SUMMARY OF CHANGES BETWEEN CONSENTED PLANNING DRAWINGS, AS PER APPLICATION REF 132952/JO/2022 AND PROPOSED SECTION 73 APPLICATION DRAWINGS:

Project Title
T2 VITA LIVING, ST. JOHNS

Drawing Title
PROPOSED WEST ELEVATION

Drawing Number
6555-P-B500-E-W

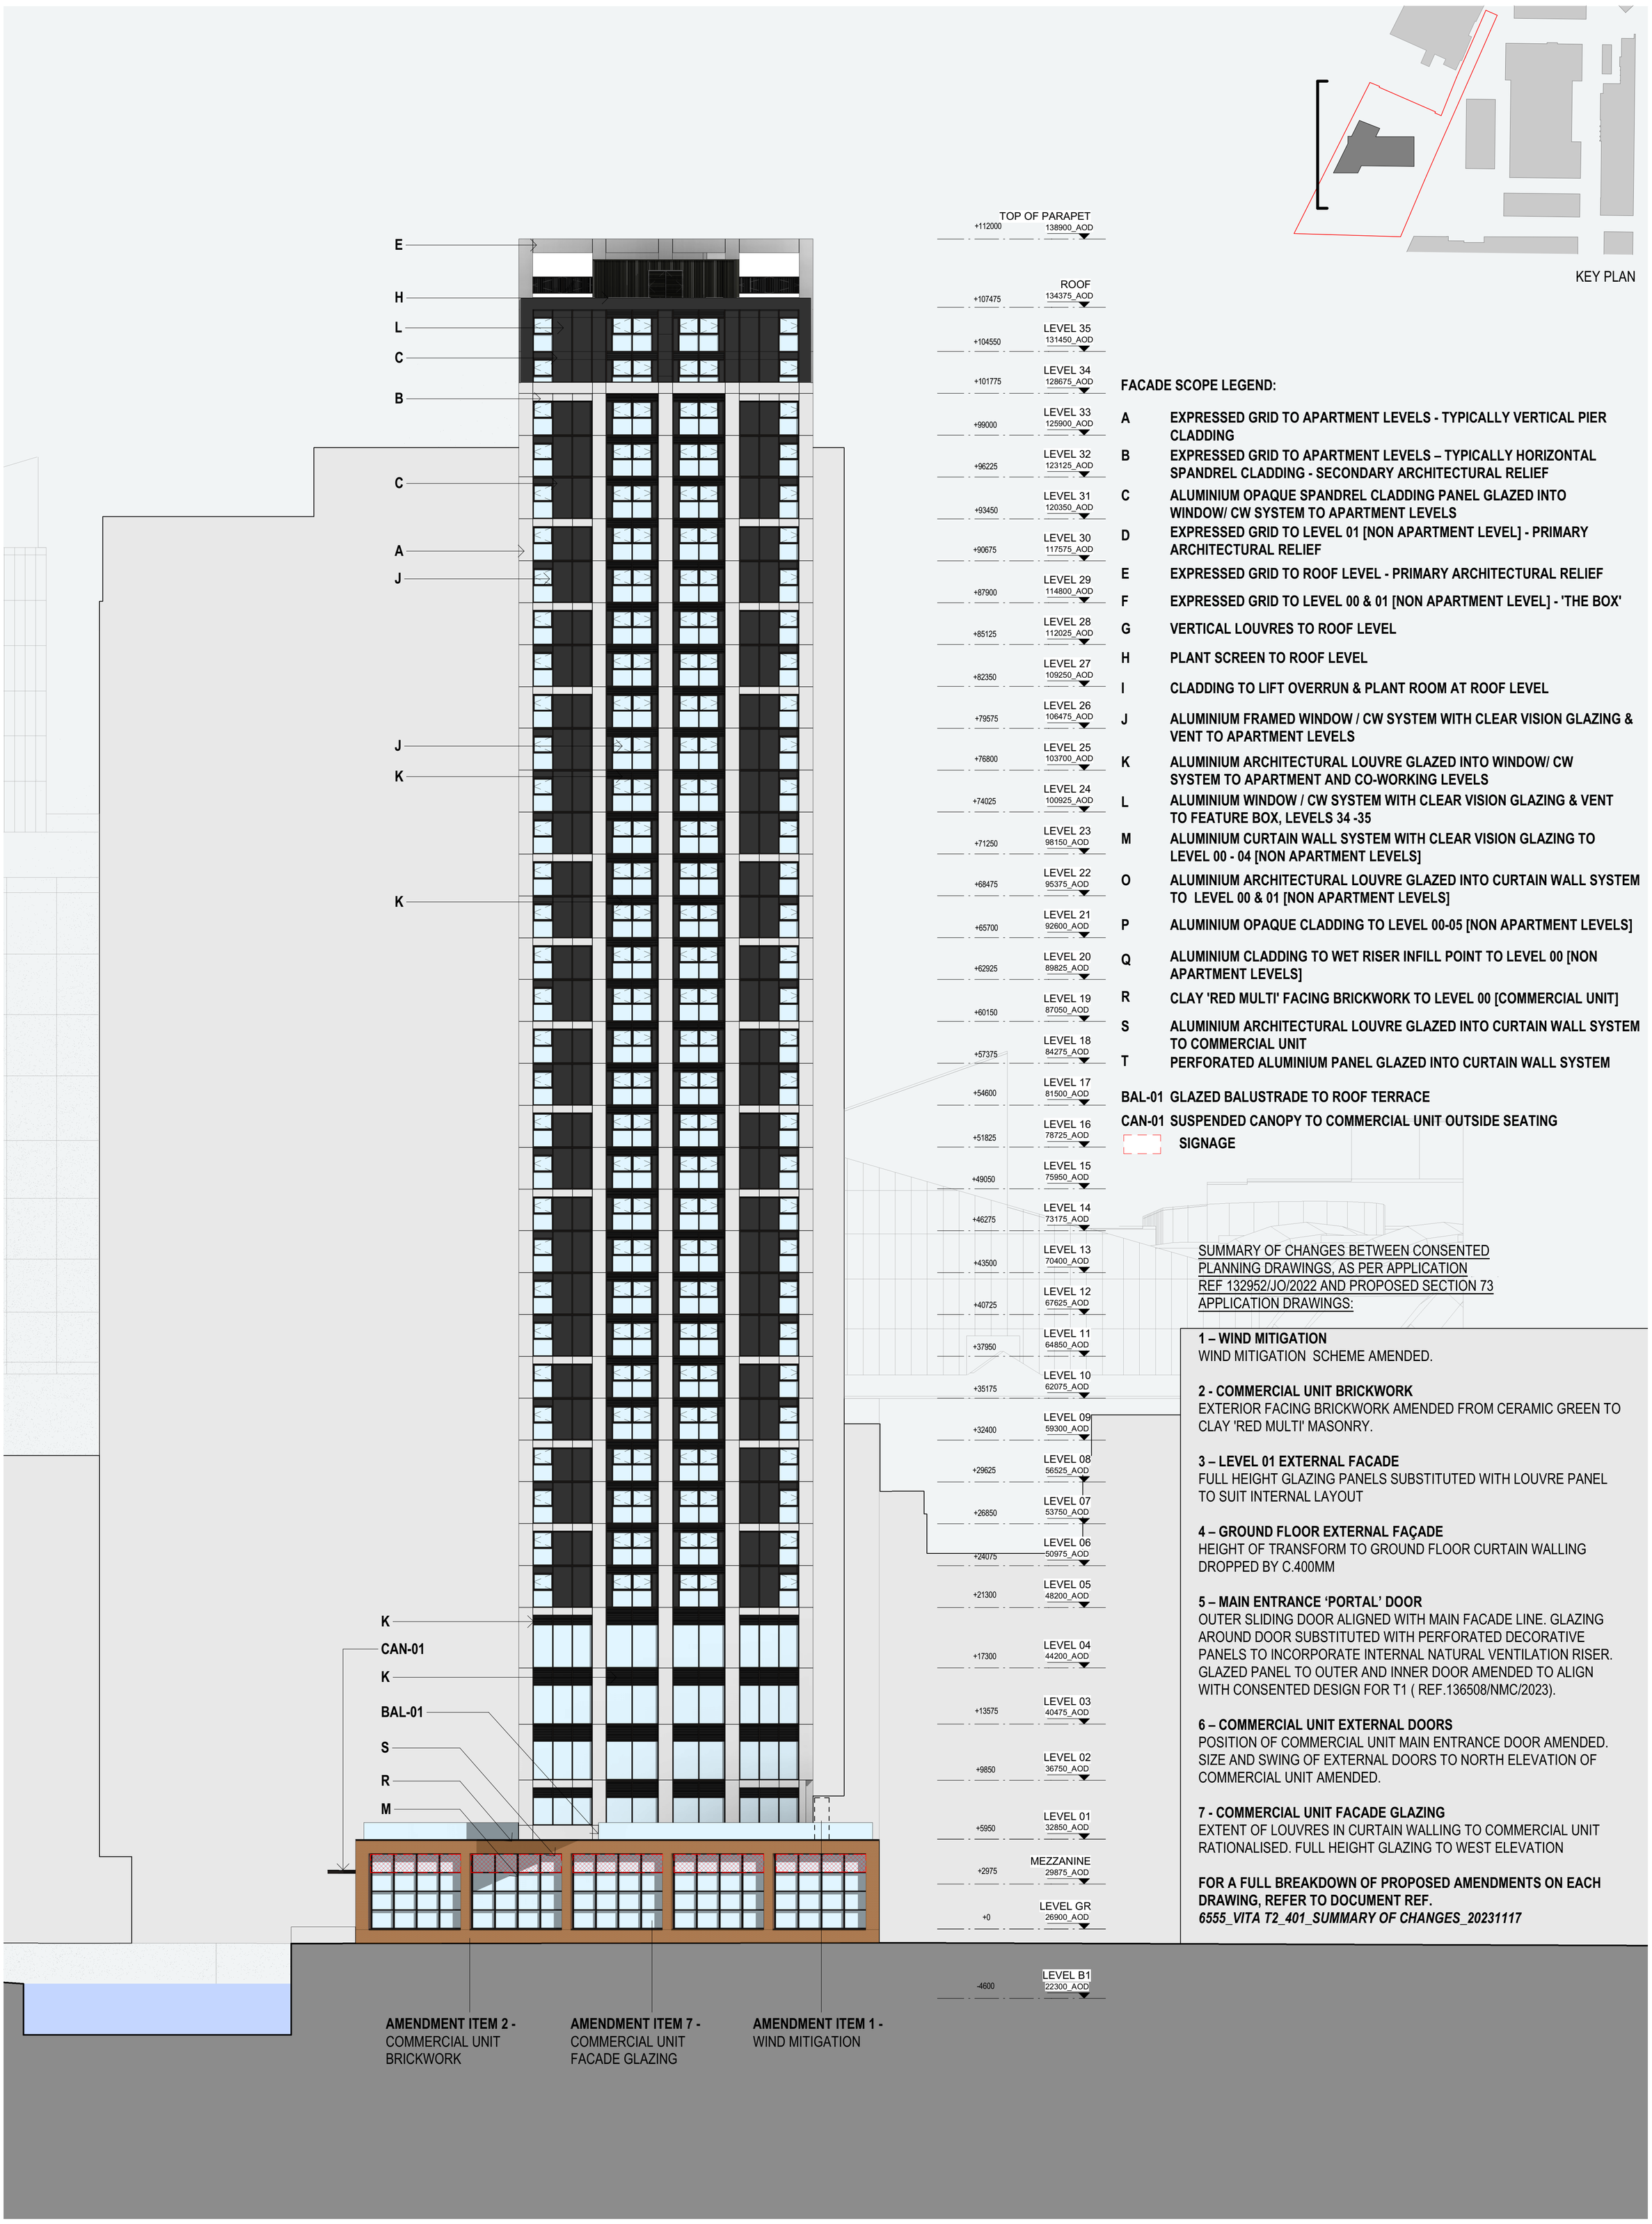
1 – WIND MITIGATION
WIND MITIGATION SCHEME AMENDED.

2 - COMMERCIAL UNIT BRICKWORK
EXTERIOR FACING BRICKWORK AMENDED FROM CERAMIC GREEN TO CLAY 'RED MULTI' MASONRY.

3 – LEVEL 01 EXTERNAL FACADE
FULL HEIGHT GLAZING PANELS SUBSTITUTED WITH LOUVRE PANEL TO SUIT INTERNAL LAYOUT

4 – GROUND FLOOR EXTERNAL FAÇADE
HEIGHT OF TRANSFORM TO GROUND FLOOR CURTAIN WALLING DROPPED BY C.400MM

5 – MAIN ENTRANCE 'PORTAL' DOOR
OUTER SLIDING DOOR ALIGNED WITH MAIN FACADE LINE. GLAZING AROUND DOOR SUBSTITUTED WITH PERFORATED DECORATIVE PANELS TO INCORPORATE INTERNAL NATURAL VENTILATION RISER. GLAZED PANEL TO OUTER AND INNER DOOR AMENDED TO ALIGN WITH CONSENTED DESIGN FOR T1 (REF.136508/NMC/2023).

6 – COMMERCIAL UNIT EXTERNAL DOORS
POSITION OF COMMERCIAL UNIT MAIN ENTRANCE DOOR AMENDED. SIZE AND SWING OF EXTERNAL DOORS TO NORTH ELEVATION OF COMMERCIAL UNIT AMENDED.

7 - COMMERCIAL UNIT FACADE GLAZING
EXTENT OF LOUVRES IN CURTAIN WALLING TO COMMERCIAL UNIT RATIONALISED. FULL HEIGHT GLAZING TO WEST ELEVATION
